SUNDRY NOTICES AND REPORTS ON WELLS

8. Well Name and No.  
H.E. West "B" #7

\* REVISED \*

# DEVON ENERGY OPERATING CORPORATION WELLBORE SCHEMATIC

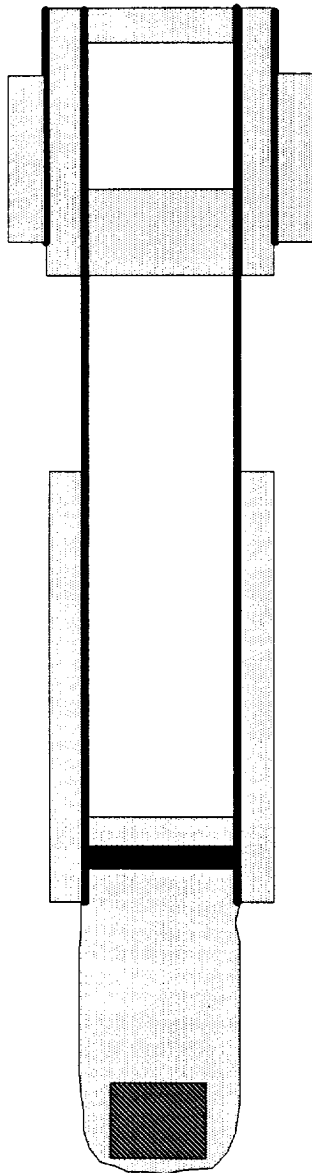
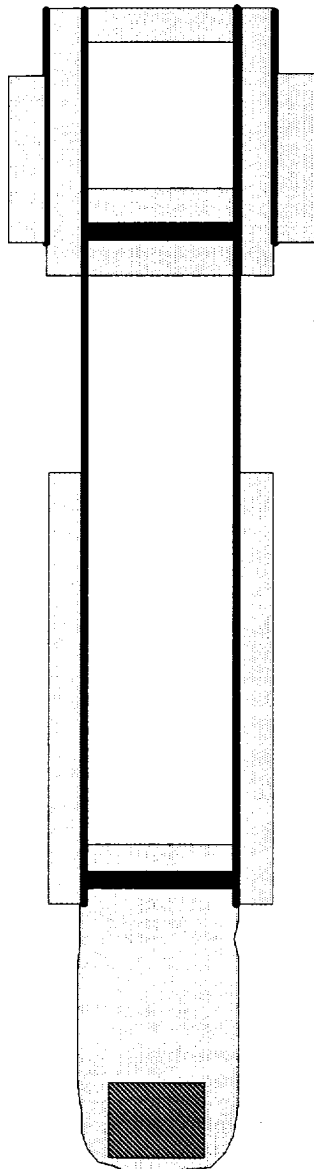
1. Set cement retainer @ 3025', pump 335 sxs "C" below retainer and cap retainer with 50' cement.
2. Perforate 7" casing @ 695'( $\pm$ 50' below surface casing shoe). Pump sufficient volume of cement to circulate to surface in 7"- 8 5/8" annulus, displace cement to 595' inside 7" casing.
3. Set cement plug 0'- 50' in 7" casing.
4. Install dry hole marker and restore location.

NOTE: 9.5ppg mud to be spotted between cement plugs. Cement to be Class "C" @ 14.8ppg. A cement bond log will be run to verify that the top of cement behind 7" casing is 100' above base of salt( $\pm$ 1575'). If required, 7" casing will be perforated and squeezed with sufficient volume of cement to insure isolation of the salt section.

CEMENT PLUG: 0' - 50' W/10 SXS

CEMENT PLUG: 595' - 695' W/165 SXS

PERFORATE 7" CASING @ 695'

CEMENT RETAINER @ 3025', PUMP 335 SXS BELOW & CAP W/10 SXS.
